STAFF REPORT

REGIONAL CENTER HEARING EXAMINER - HIGH IMPACT CASE

Case Number	2022-REG-077
Address (approx.)	902, 916, 918 and 922 North Capitol Avenue
Location	Center Township, Council District # 11
Petitioner	MTP – 922 N. Capitol Ave., LLC, by Joseph D. Calderon
Zoning	CBD-S (RC)
Request	Regional Center Approval for demolition of existing buildings and construction of a five-story, mixed-use development, with approximately 270 units, 13,840 square feet of office and retail space, a parking garage with approximately 398 spaces, and resident amenities, including an outdoor courtyard.

Floor plan – ground level

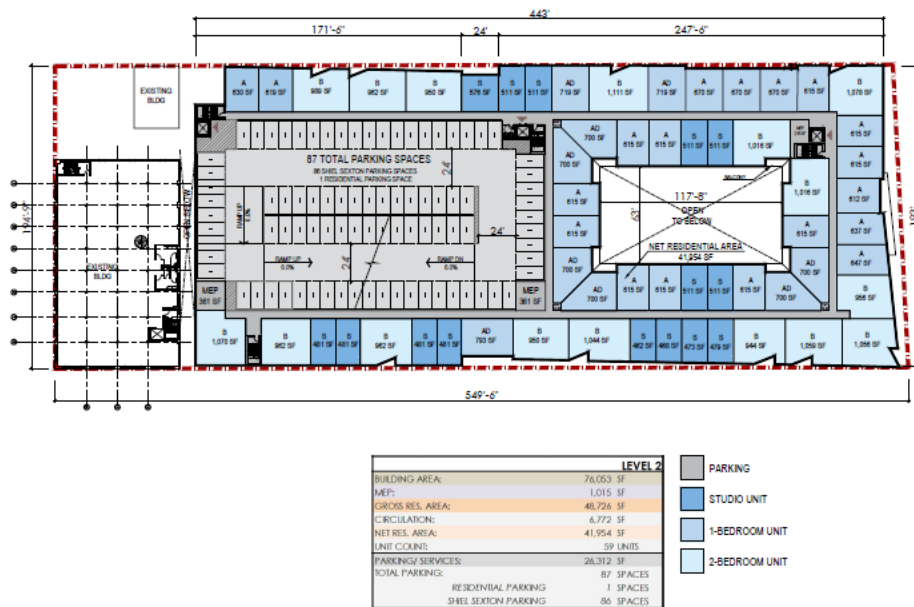
1. In consultation with the City Administrator of Long-Range Planning for Transportation, the building frontage, at the parking garage entry, should be recessed along Capitol Avenue and a right-in/ right-out designed to force vehicles to turn immediately into and out of the parking garage. Additionally, signage must be provided for appropriate information to pedestrians and drivers for staff review and approval, prior to the issuance of an Improvement Location Permit. Guidelines SC 3.3.6 and SC 3.4.3 would apply.

3. Bike parking was not detailed on the submitted plans. Amended site plans shall be submitted for staff review and approval prior to issuance of an Improvement Location Permit. Guidelines CA 4.2.2 and CA 4.2.4 would apply.

North and East elevations

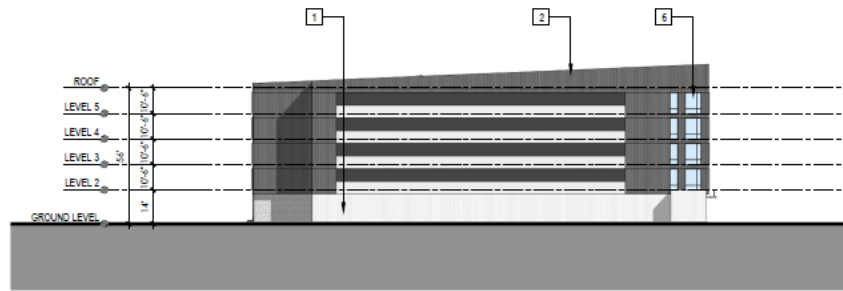
2. The south elevation of the proposed building indicates that the garage parking levels would have exposed sections, for ventilation purposes. Staff would suggest that the portion of this façade be painted a color similar to the proposed metal panels that would surround the openings along the top and sides. Guideline SC 3.3.2 applies.
